Upper South Creek

Advanced Water Recycling Centre and Pipelines

CoA E19 and E20 Rehabilitation Management Plan, RBM 12 lands –
Kemps Creek

Document No: USCP-JHG-MPL-ENV-0011

Figure 3-1 Vegetation Mapping of RBM 12 Area based on previous Promac reports and online vegetation mapping databases

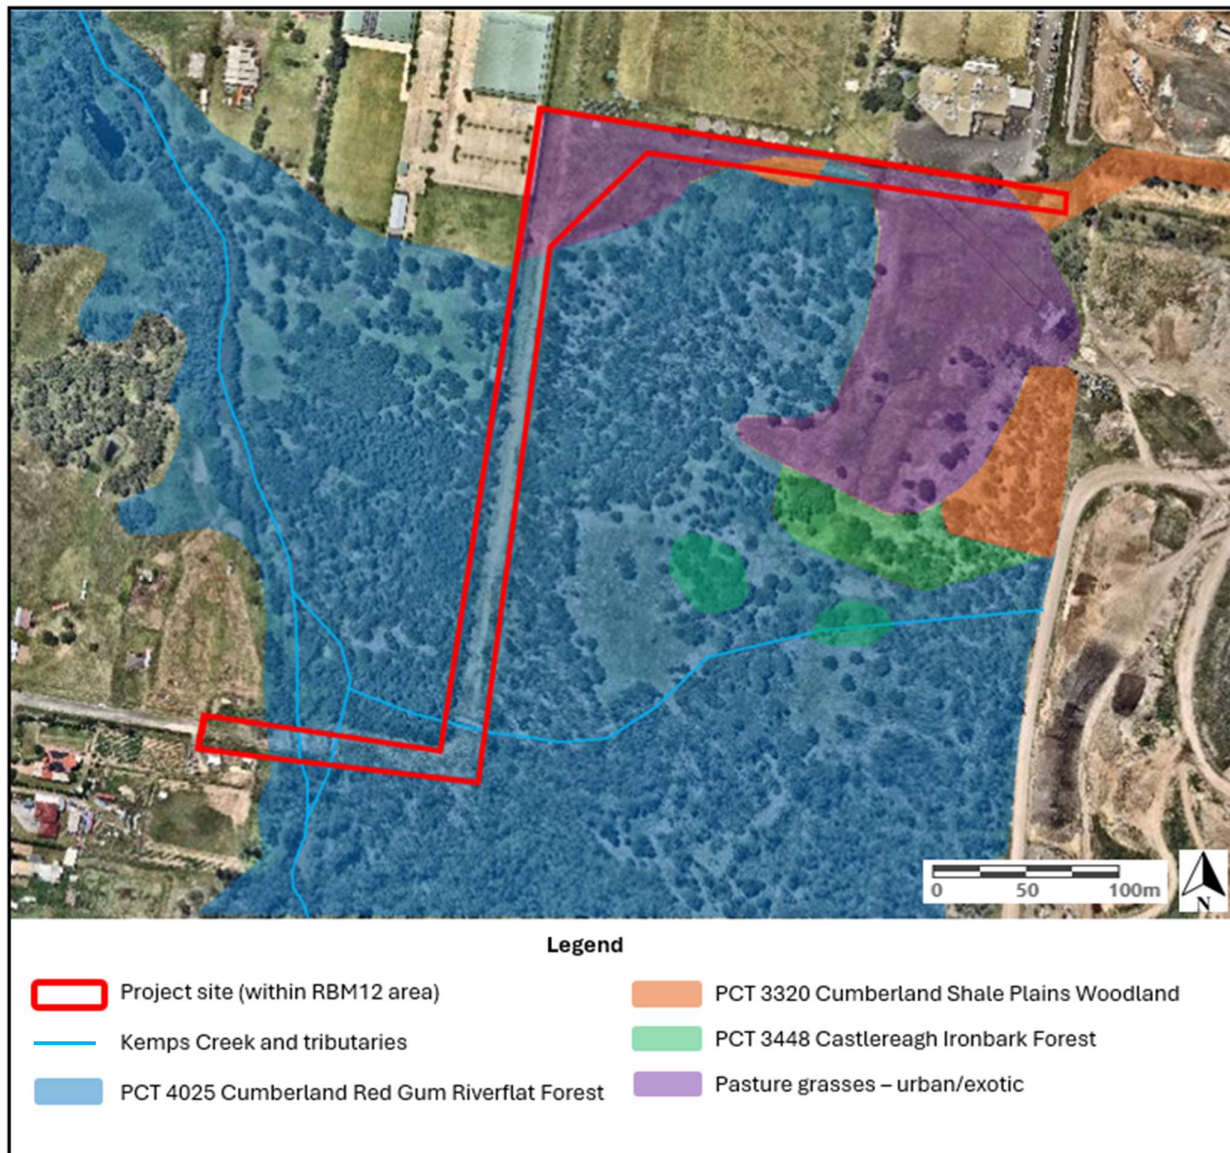
It is understood that the rehabilitation works will aim to recreate vegetation types that occurred in the area prior to disturbance. Figure 3-1 includes a map of the vegetation types in the impacted area, but the Existing Native Vegetation in the surrounding RBM 12 lands is not mapped to vegetation type. It would be useful if Figure 3-1 included a map of the vegetation types in the surrounding RBM 12 lands area, as this would justify why the vegetation types in the impacted area were chosen. Section 3.1 also indicates that vegetation in the corridor appears to be currently mowed and slashed, it is assumed by BCS this will cease with the implementation of the RMP.

References to the grassed area in Section 2.3 have been clarified throughout the document and added to Figure 3.1 as Pasture grasses - native/exotic.

Figure 3-1 has been updated to better show the vegetation types in the surrounding RBM12 lands area to justify selection of vegetation types used for rehabilitation. The adjacent PCTs layers have been sourced from both the Promac assessment and online vegetation mapping databases. Slashing/mowing in rehabilitated areas mapped as PCT 3320 and 4025 in Figure 3-1 will cease following rehabilitation. Land mapped as pasture grass grazing land will continue to be managed by the landowner which may be subject to mowing and/or grazing which is consistent with land management practices pre-promac construction.

Figure 4-1 Diagram of approximate widths of revegetation zones in relation to SW pipeline assets.

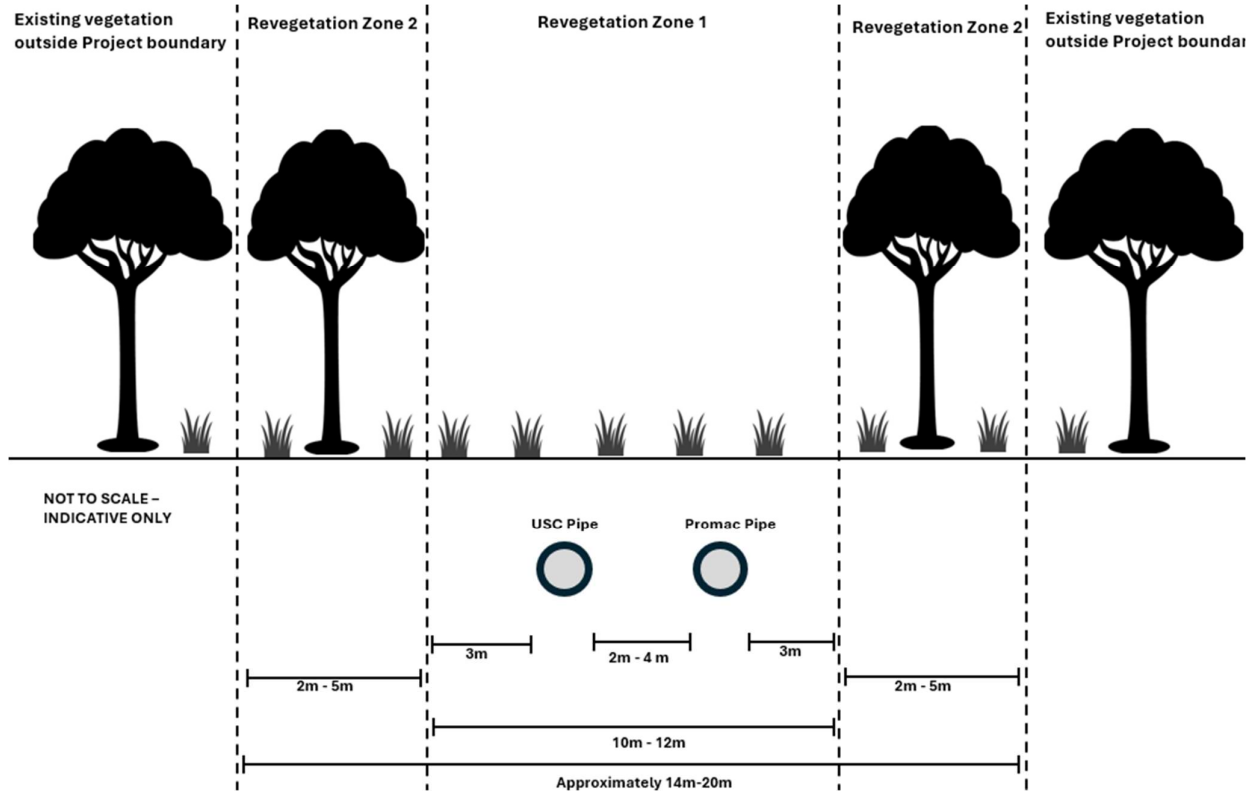
Section 4.3	<p>Riparian Vegetation Zones</p> <p>We are currently reviewing the updated RMP and just wanted to clarify one of the comments in Section 4.3 (below) about the riparian vegetation zone. Can you please provide further clarification where this specifically this applies?</p>	22 May 2024	<p>22 May 2024</p> <p>The waterways and subsequent riparian zones within the RBM12 are limited to the areas immediately adjacent to Kemps Creek and the two unnamed tributaries as provided in Figure 3-1. These areas are relatively small in comparison to the remaining non-riparian areas to be rehabilitated.</p> <p>Just to confirm, we will still plant trees and shrubs in revegetation zone 2 in those riparian areas however revegetation zone 1 (directly on top of the pipelines) will be limited to grasses to ensure there is no adverse effect to the functioning of the pipeline</p>

As requested by BCS, a diagram has been added to Figure 4-1 which indicatively shows the location and widths of Revegetation Zones 1 and 2 in relation to SW pipeline assets.

Figure 4-1 Diagram of approximate widths of revegetation zones in relation to SW pipeline assets.

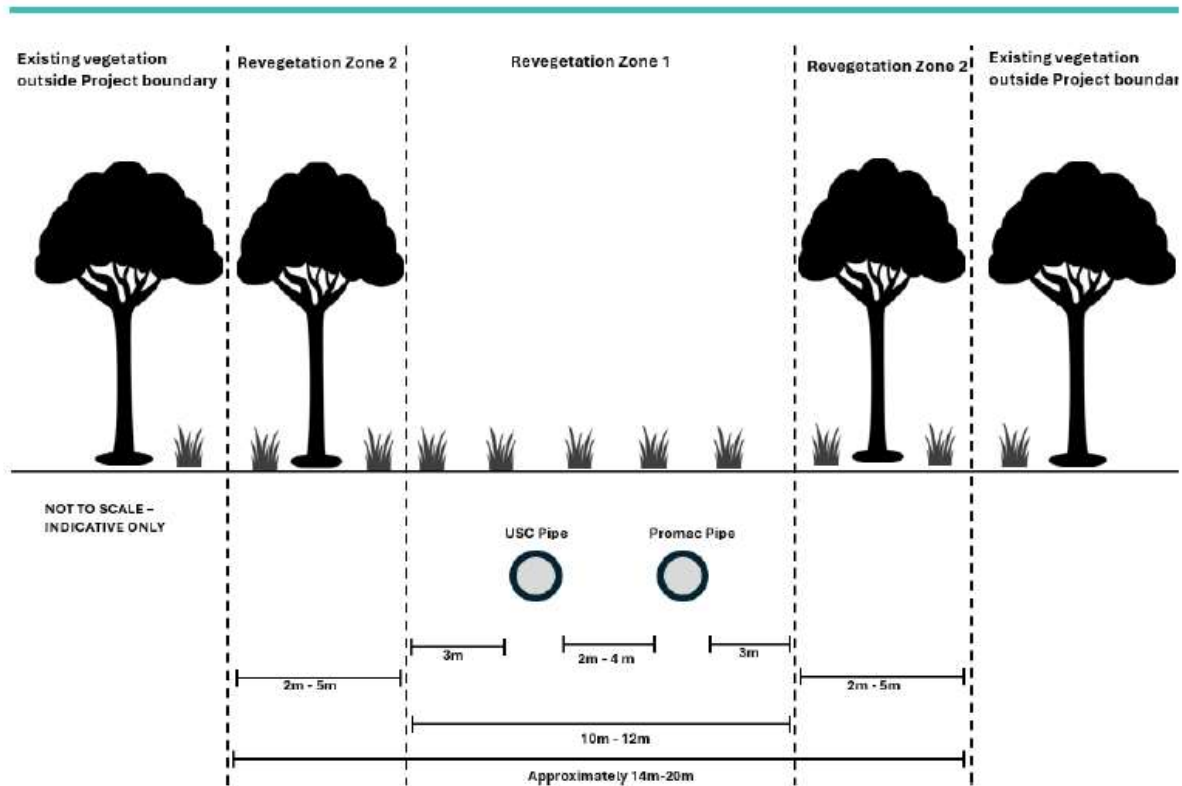
We are currently reviewing the updated RMP and just wanted to clarify one of the comments in Section 4.3 (below) about the riparian vegetation zone. Can you please provide further clarification where this specifically this applies?

Thanks for the call earlier. As discussed, the waterways and subsequent riparian zones within the RBM12 are limited to the areas immediately adjacent to Kemps Creek and the two unnamed tributaries as provided in Figure 3-1. These areas are relatively small in comparison to the remaining non-riparian areas to be rehabilitated.
